25 Jun 91
17th St, Outfall Canal West Bank

SUBJECT: Lake Pontchartrain, Louisiana and Vicinity Hurricane Protection Project, High Level Plan, Design Memorandum No. 20 - General Design, 17th Street Outfall Canal - 1st End Comments

SUBJECT: Lake Pontchartrain, Louisiana and Vicinity, High Level
Plan, Design Memorandum No. 20 - General Design, 17th Street
Outfall Canal

"J" WATERSTOP (P.V.C.)
SCALE: 1/2" = 1'-0"

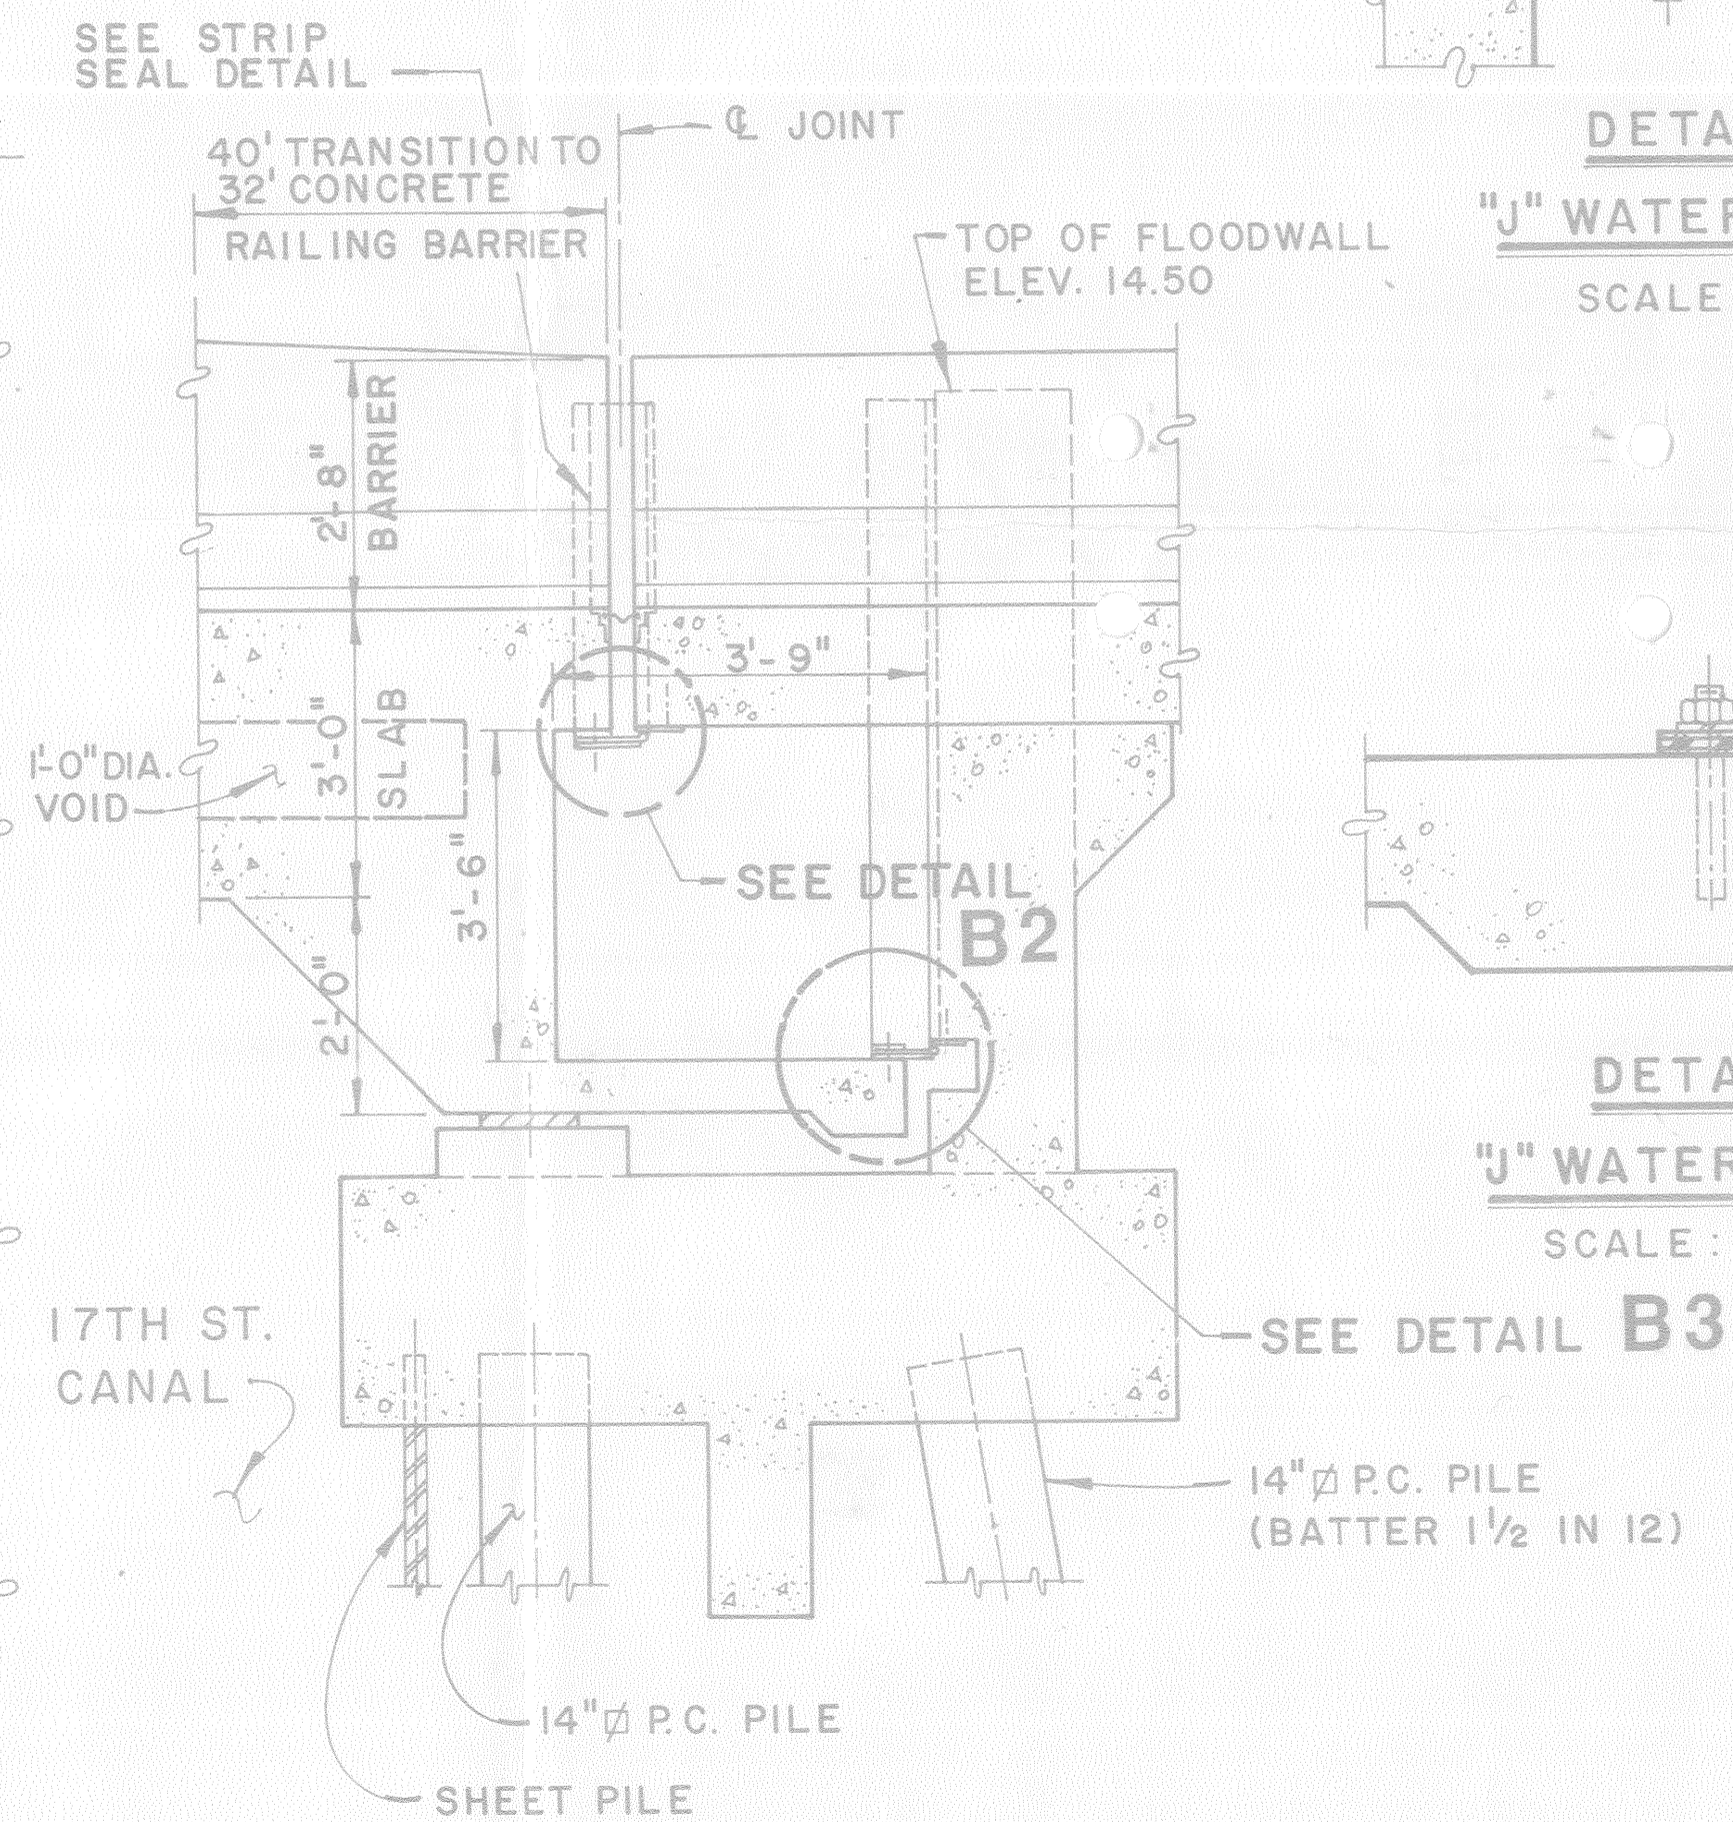
3. At the west abutment of the bridge, a seal system with multiple backups, including a reservoir, will be employed beneath the bridge to prevent water intrusion from the canal. The reservoir will provide a holding area to test for leaks in the seals. It would only be necessary to pump water into the reservoir, and monitor the water level over a period of time. Portable pumps will be required for this procedure. A periodic testing and maintenance program by LDOTD will be required to assure proper working of seals.

1. The concept of the Joint Sealing shown on the subject preliminary plans is acceptable.
2. The final submittal should include joint details with critical dimensions affecting the joint sealing material. Design computations, showing the stability of the structure under normal loading conditions as well as flood condition, must also be submitted for our review.

Detail of 17th St. Canal Bridges Plan & Profile

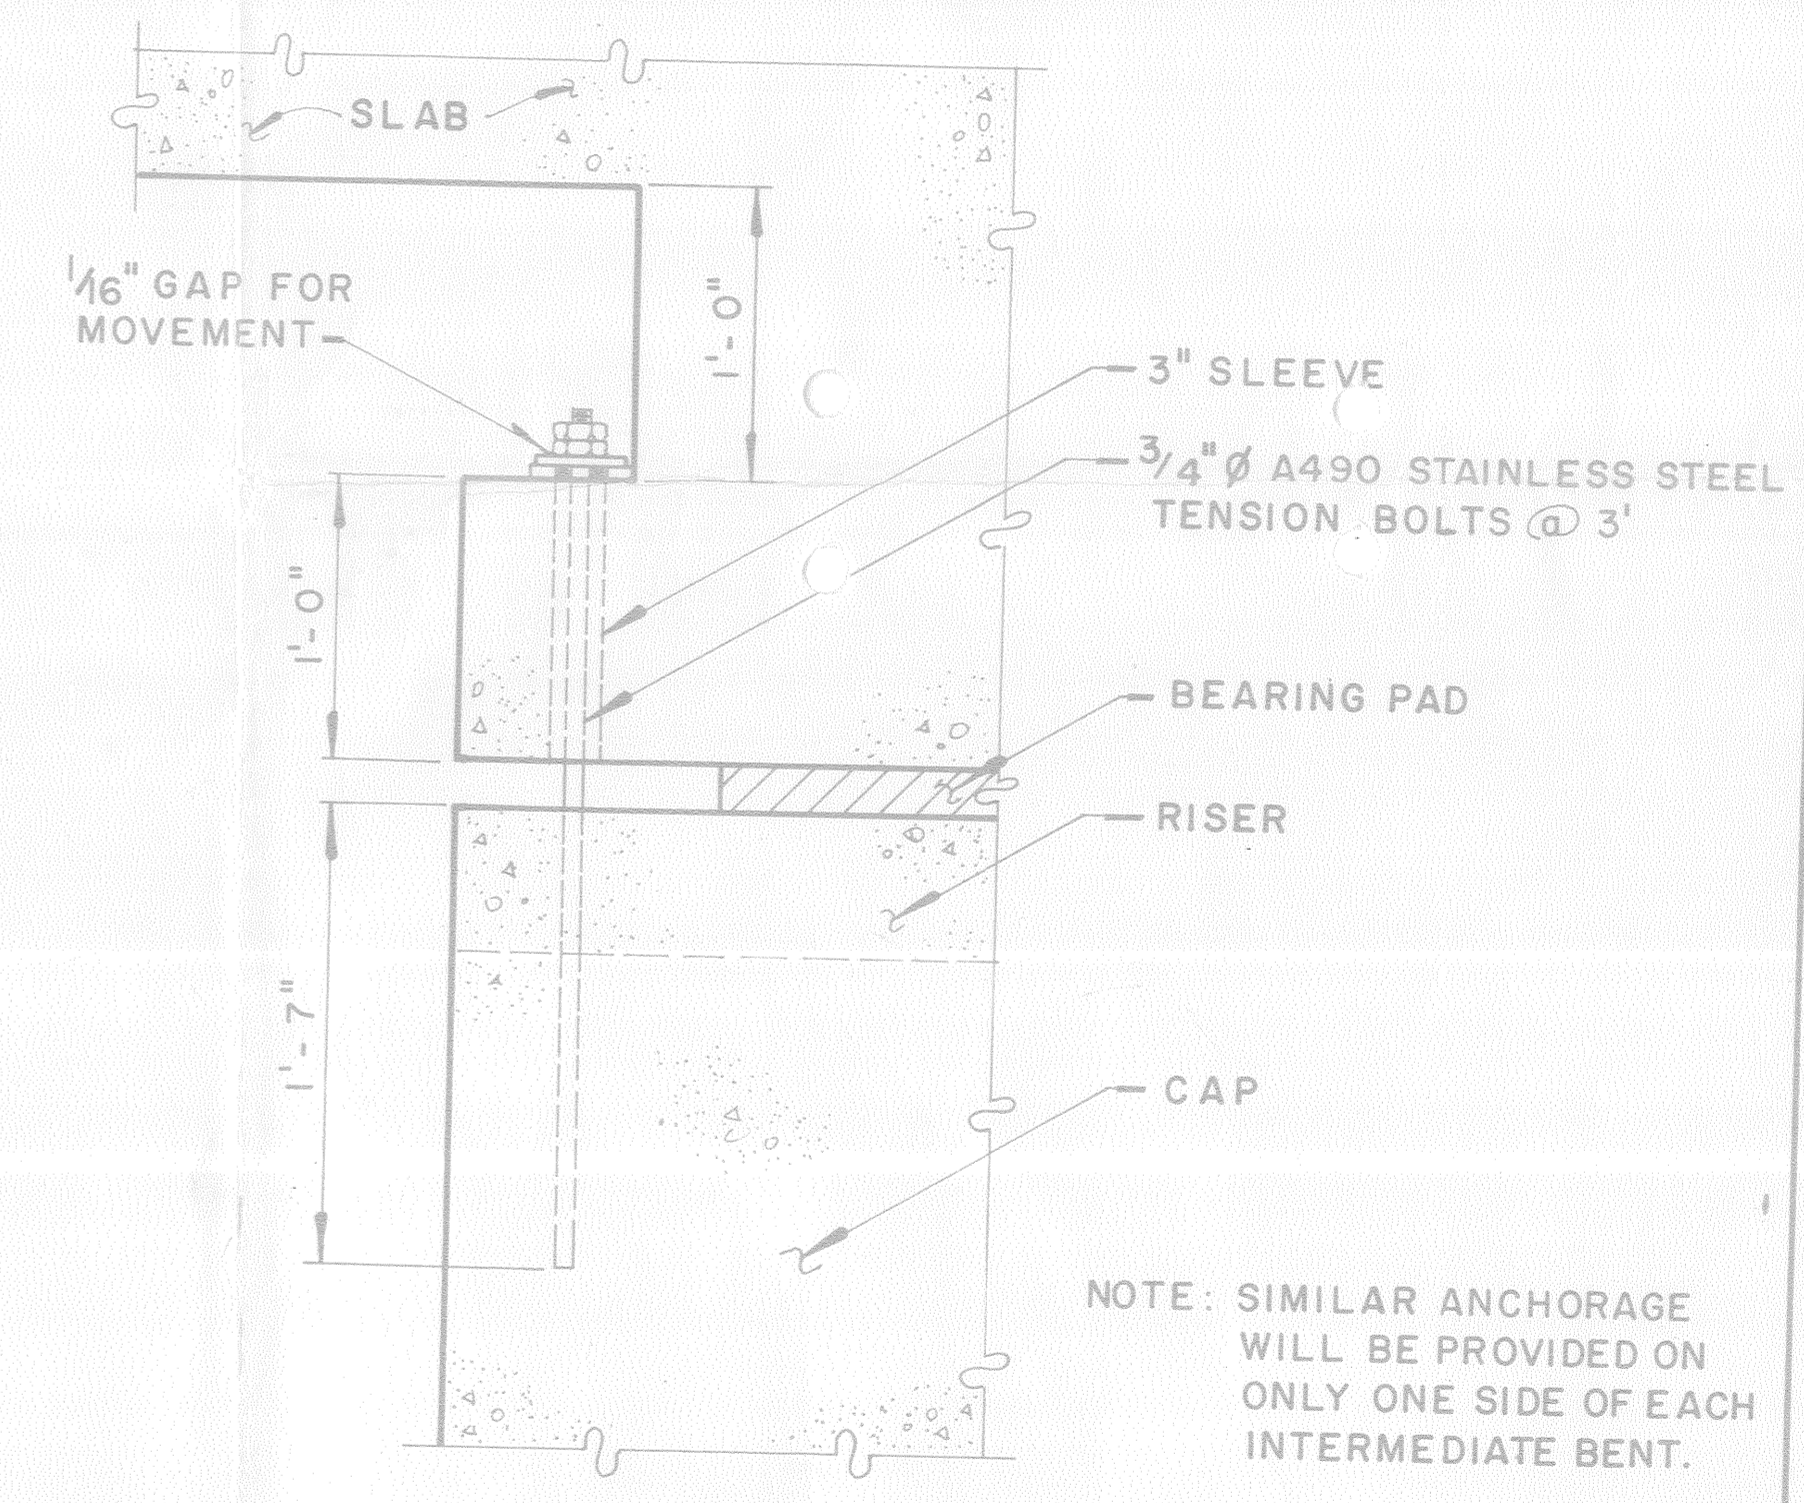
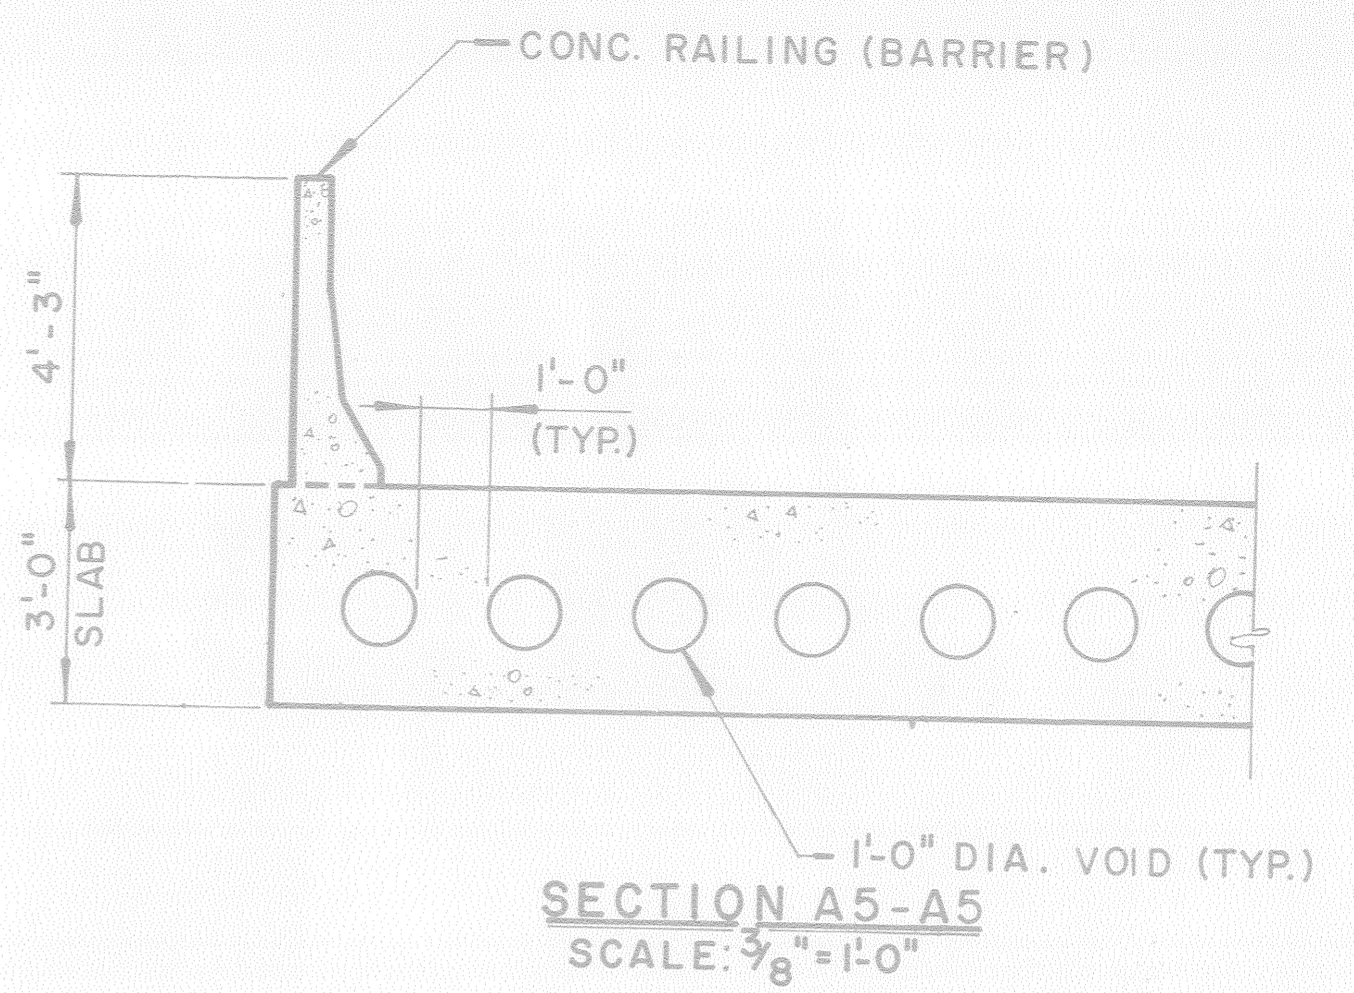
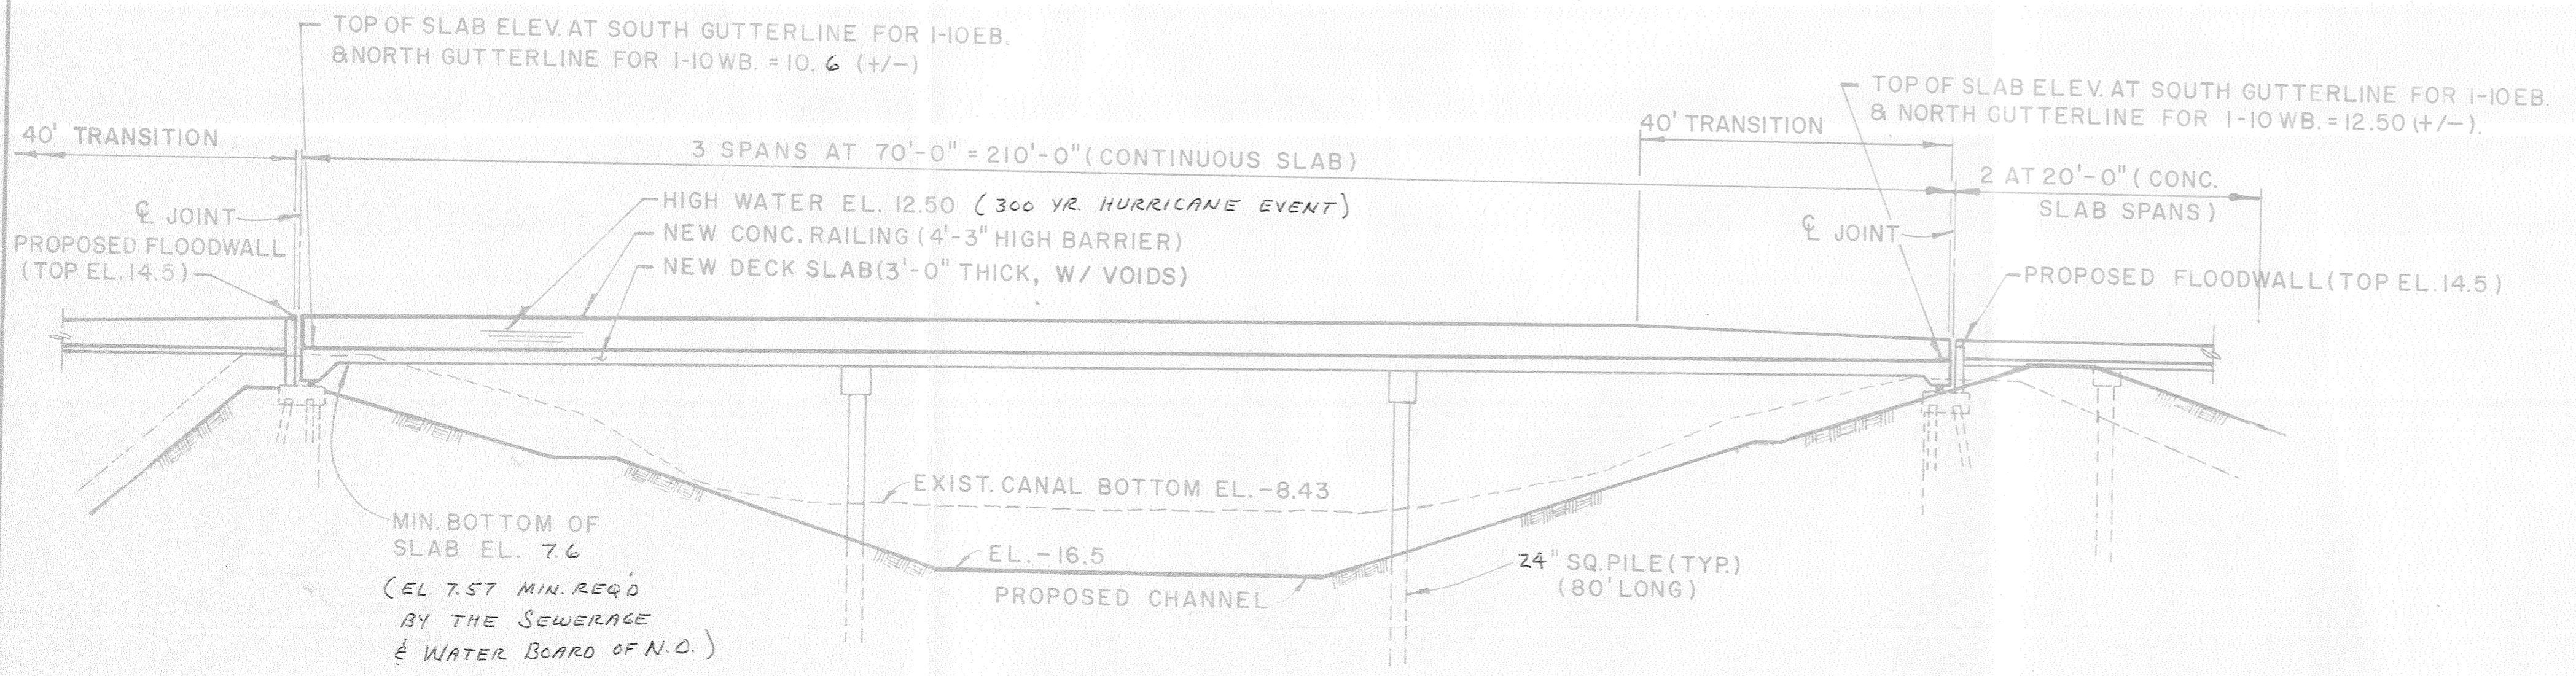
The new bridges over the canal will be built with three continuous spans of 3' thick voided slab and 4'-3" high concrete railing. It is recommended to provide 3' thick voided slab instead of precast concrete girders or cast-in-place rectangular concrete girders in order to have sufficient weight to overcome the uplift force from the canal water. The top of concrete railing will be at same elevation as the floodwall elevation which is 14.50. The high water elevation is at 12.50 which is 2'-0" above the bridge deck at west abutment. In order to keep water from coming in on the bridge deck, joint at both ends of 210' span over the canal must be sealed.
